Subject: Request for Response to MMD Comment Letter of October 27, 2020,
Slope Stability Analysis Timeline, Socorro Mine and Mill Revision 19-1
Application, Permit No. SO001RE, Socorro County, New Mexico

DICAPERL MINERAL CORP.
 SOCORRO MINE
 SOCORRO, NM

SOCORRO MINE SITE PLAN

PROJECT NO. 106779.TK11
 FILE NAME: C-1.DWG
 FIGURE NO.
 C-1

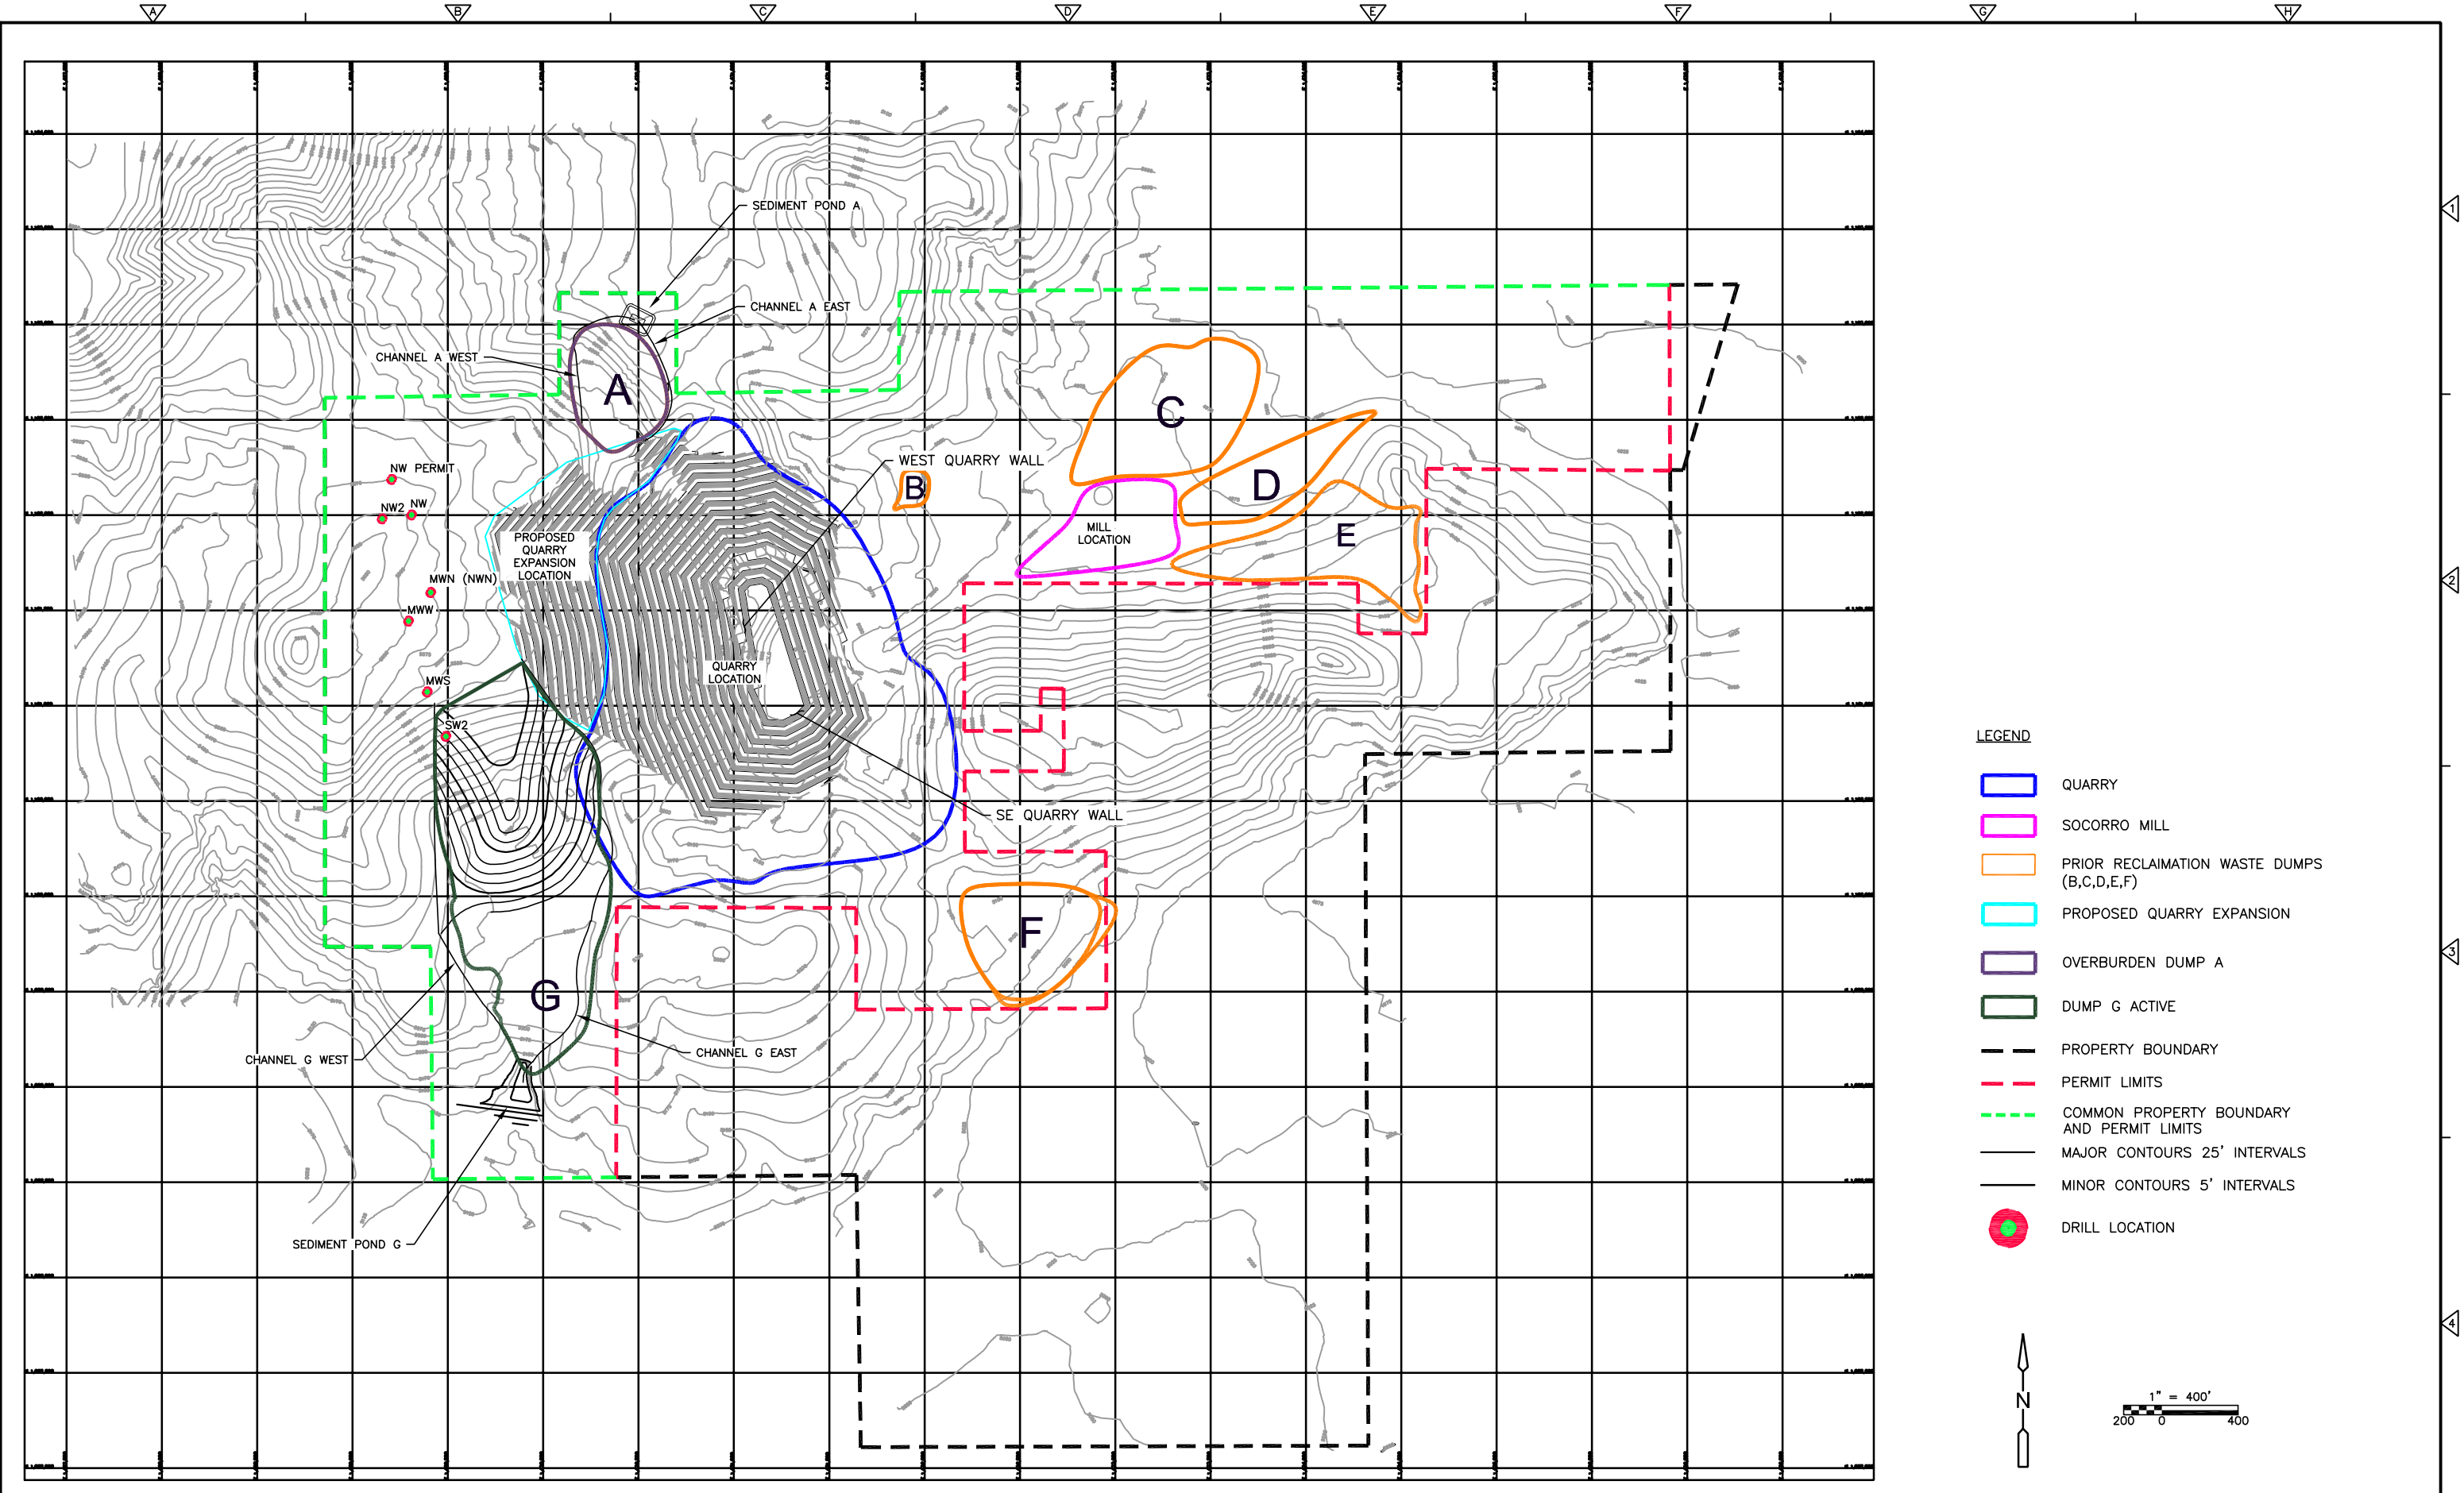
1. MMD expressed concern that the proposed boreholes shown on Figure C-1 dated September 2020 and submitted with the Slope Stability Analysis Timeline do not fall within the Proposed Quarry Expansion Location and requested that the CDM Smith Geotechnical Engineer review those proposed borehole locations and describe in writing how their locations were chosen and how they will support slope stability analysis of the Proposed Quarry Expansion, and add additional borehole locations as required for the analysis.

- a. The locations of 7 boring as shown on Figure C-1 are within the common property boundary and permit limits and were selected by the mine management with the primary objective of determining overburden thickness to assist in mine operation planning and to confirm the economic viability of future mining operations.

- b. The CDM Smith Draft Technical Memorandum – Work Plan for Slope Stability Assessment, dated December 30, 2019 (subsequently referred to as Work Plan) suggested that these exploratory borings drilled for mine operation planning purposes are also being utilized to obtain cores of the perlite rock beneath the overburden for laboratory testing of strength characteristics. The mine management is following this suggestion.

- c. The Work Plan presented the approach of conducting additional data collection efforts of rock mass characteristics including joint system orientations when the pit slopes are being set back and to add this data to the existing data base to either confirm the continued validity of the kinematic analyses performed to date or to indicate if conditions change. In the case of the latter, more complex modeling of the rock mass would be required. If more complex rock mass modeling is being performed, laboratory testing results of rock core strength characteristics would be needed as model input data. To prepare for this eventuality, taking rock cores as the opportunity arises and performing laboratory testing (unconfined compressive strength (UCS)) was suggested. It should be noted that the rock core test results are not being considered in the kinematic analyses. In the case of continuing reliance on kinematic analyses for slope stability assessment as long as joint system orientations indicate stable slopes from a kinematic viewpoint, these lab test results serve as reference, e.g. to compare perlite rock to other more common rock types, which will allow to respond to related questions.

- d. The question if the perlite cores obtained at the proposed boring locations will be representative for the perlite rock exposed when the pit slopes are being set back within the area of the Proposed Quarry Expansion Location per Figure C-1 at this time can be evaluated only based on the perlite deposit that has been mined to date and the perlite rock currently exposed at the pit walls. Based on observations, the deposit appears to be relatively uniform. The rock cores that we anticipate to obtain from the planned exploratory borings will either confirm or invalidate the current expectation of this relative uniformity of the deposit extending to the west. If visual inspection of the perlite cores confirms relative uniformity, selected cores will be shipped to a geotechnical laboratory for UCS testing.

- e. Should the results of the planned coring effort indicate that the assumption of continued relative uniformity of the perlite deposit to the west cannot be confirmed, mine management may authorize the drilling of 1 or more additional borings within the Proposed Quarry Expansion Location per Figure C-1 or, in the case of access issues, authorize obtaining rock cores by conducting 1 or more borings on the benches of the existing quarry pit.
